### CITY PLANNING COMMISSION

Special Permit to develop 48 condominium units

3801 Norwood Avenue

P83-095 APPLC. NO. .

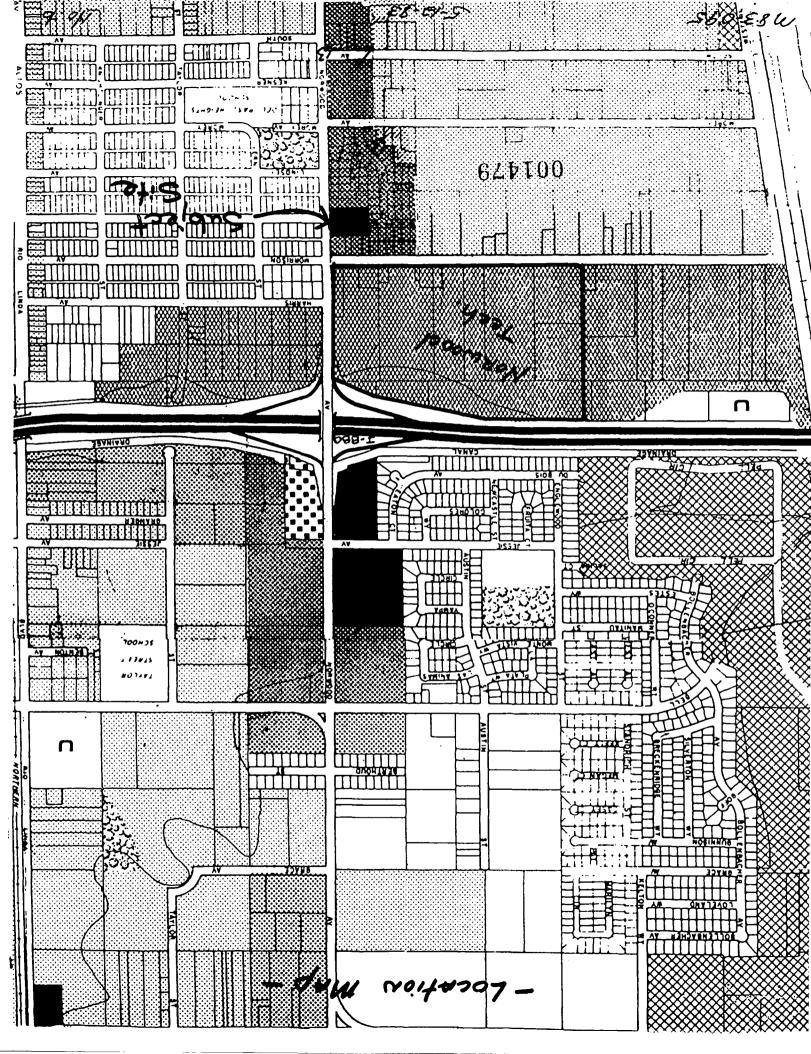
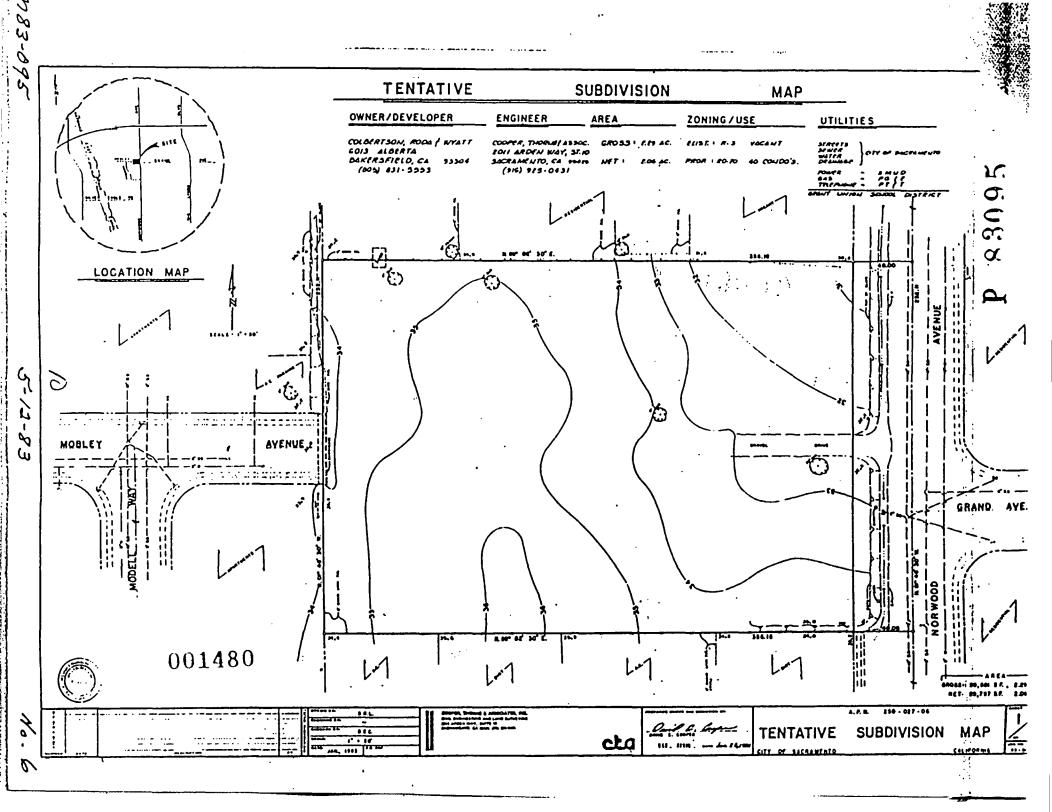
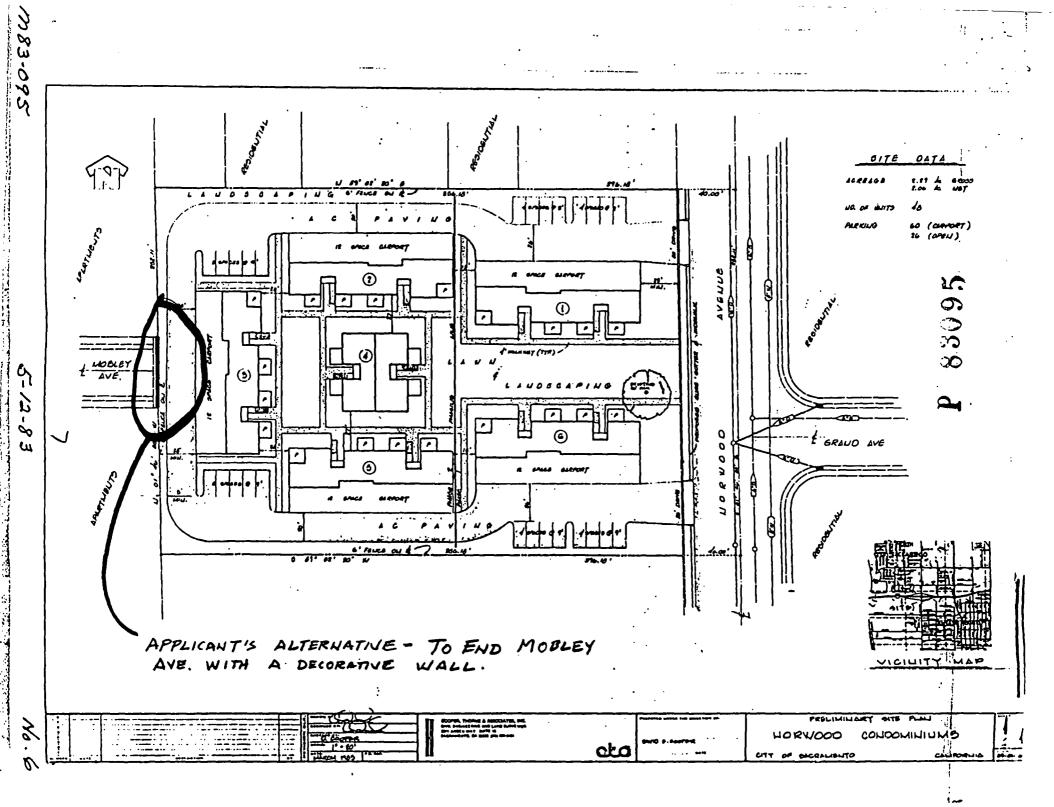
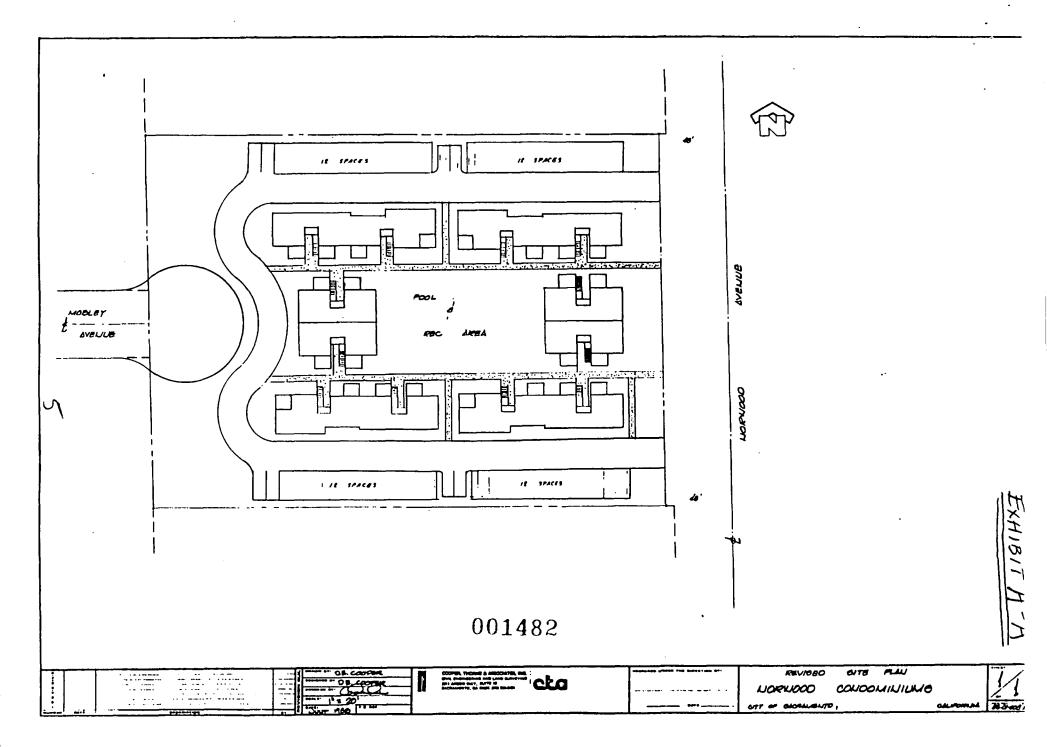
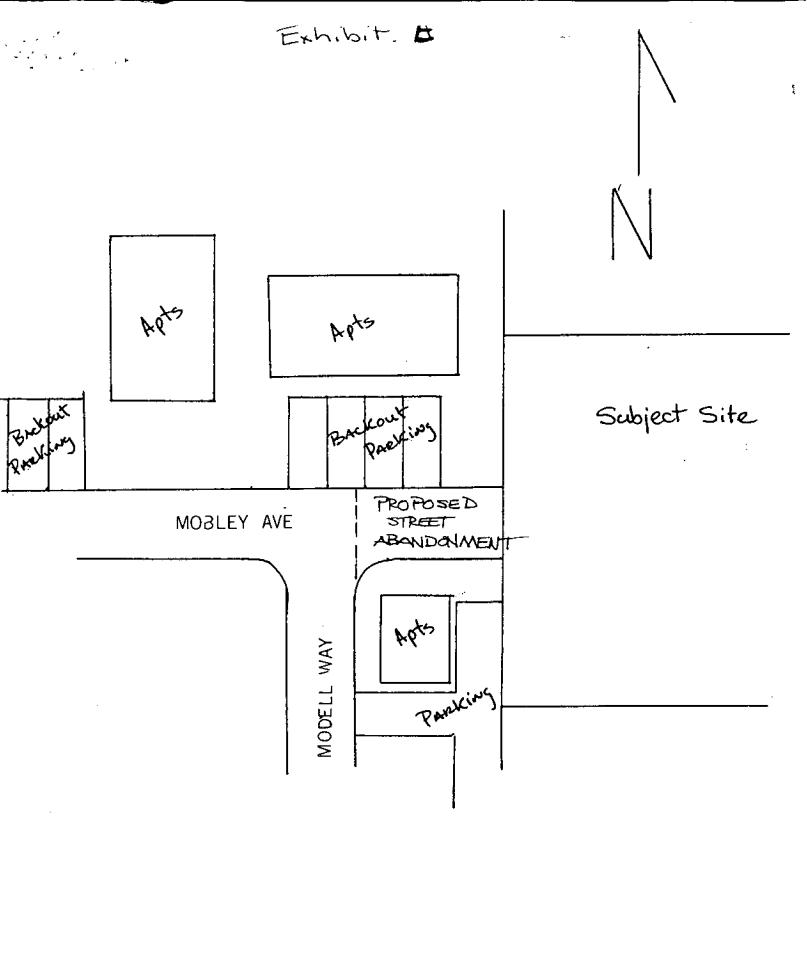
To provide for solar access staff recommends that south facing glazing be required on the units indicated on Exhibit 'D'. This exhibit indicates side on units as well as units with the rear of the units facing south. Staff notes that this recommendation is consistent with the design modifications discussed under Item 6.

If the solar access is provided on this unit indicated in Exhibit 'A' the overall north/south orientation and solar access combined will equal 80 percent as required by the General Plan.
